PUBLIC WORKS COMMISSION
CITY AND COUNTY OF SAN FRANCISCO

Correspondence Log

Subject: Response Through Chair Regarding Claremont, Juanita and Yerba Buena Pavement Renovation and Sewer Replacement Project

Claremont, Juanita, and Yerba Buena Pavement Renovation and Sewer Replacement – Project Locations

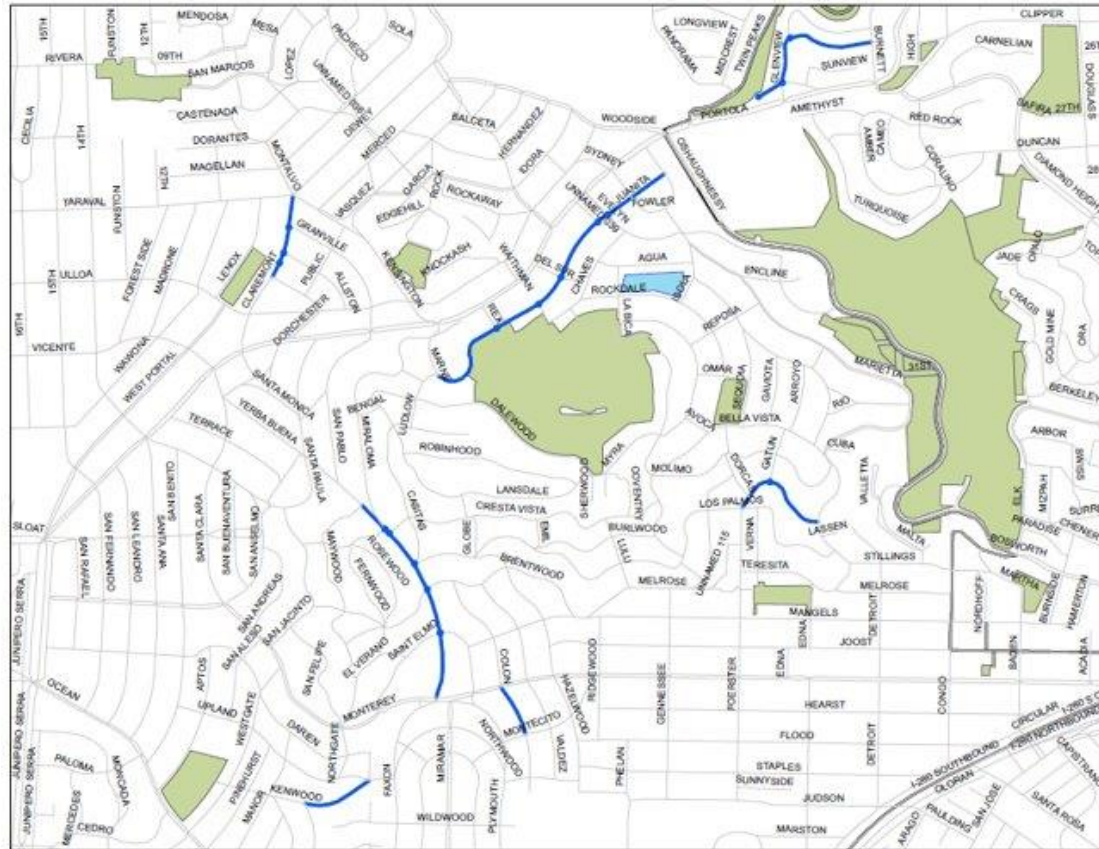
- 1). With the exception of Portola, all street sections to be torn up are quite short. Why aren't larger stretches being upgraded to maximize economies of scale and minimize the number of disruptions to neighborhoods?
- 2). Given the reliability of finding surprises underground, is 290 days + 29 days contingency realistic to complete this work?

- 1). Public Works Street Resurfacing Program Various Locations projects are typically comprised of 25 blocks to 50 blocks, of which can be single block or a few blocks in a row, generally within the same neighborhood vicinity (refer to attached map). The selected locations of work are usually determined by the need for pavement resurfacing or Pavement Condition Index Score (PCI Score) but can also be determined by other factors such as coordination with other City or private excavation projects. The economies of scale are realized by the number of resurfacing blocks in the project, typically around 25 to 50 blocks per project. The disruption to the neighborhood is also minimized due to the blocks being relatively close to each other in proximity.

- 2). Yes. The project has been through various design and construction reviews and the contract duration set is realistic. This project is on the smaller size for typical paving projects and has 25 blocks to pave with only 5 of those blocks having sewer work where underground digging will be required.
